Dear Case Officer for Application 253071.

I am writing to formally object to the above planning application. The current proposal fails to meet the standards set out in the Wokingham Borough Design Guide and the Core Strategy.

Layout 2 – Taken from the Archaeological Study as part of “Application for submission of details to comply with the following condition of planning consent 232704 dated 12/05/25. Condition 39 relates to Archaeology.” Submission 253117

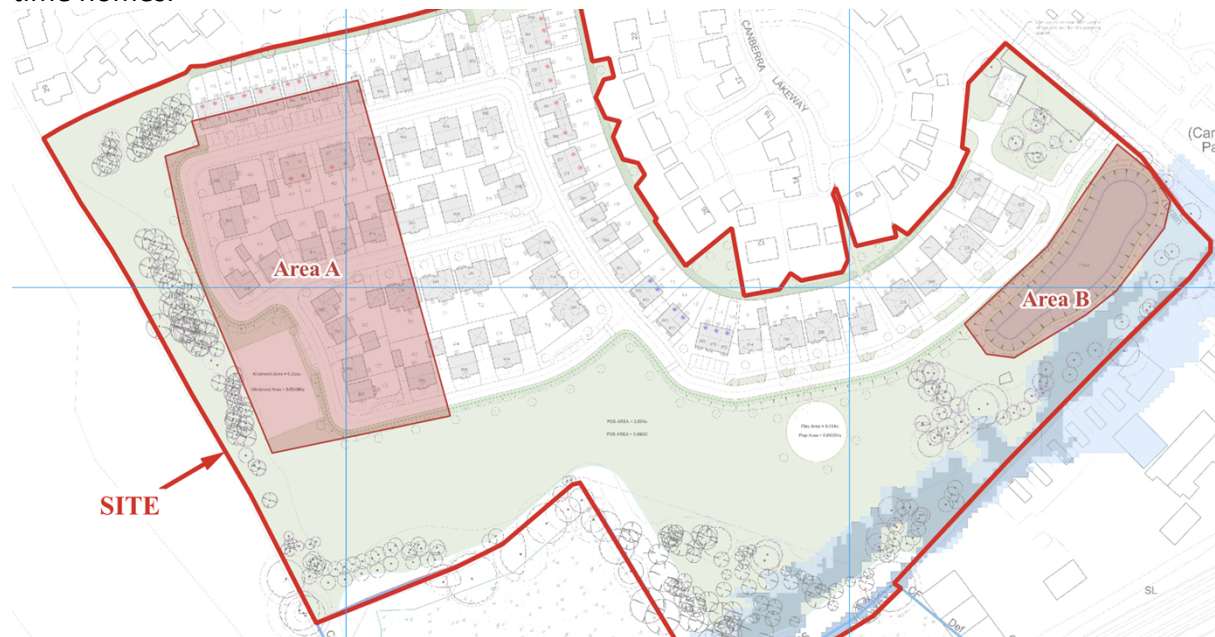
This layout is more sympathetic to CLW25 and respects, to a certain extent, the landscape buffer between Bellway75 and CLW25. This is the closest to an acceptable solution, but still not perfect. It also has a far better ‘pepper pot’ distribution of social, affordable and first time homes.

Layout 3 – “Taken from the P250896 Flood Risk Assessment and Drainage Strategy Report Pt 2” as part of the main submission 253071

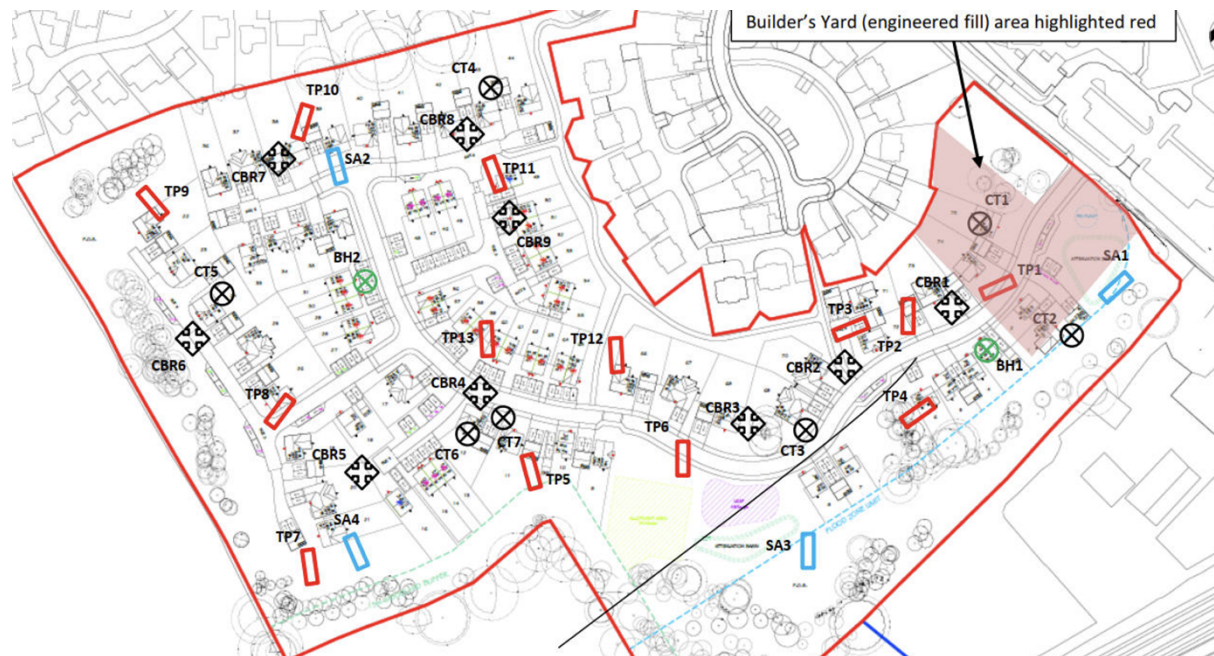
Again, this diagram respects landscape buffers, a better distribution of house types and sizes and allows a better level of privacy and visual amenity to existing properties in CLW.
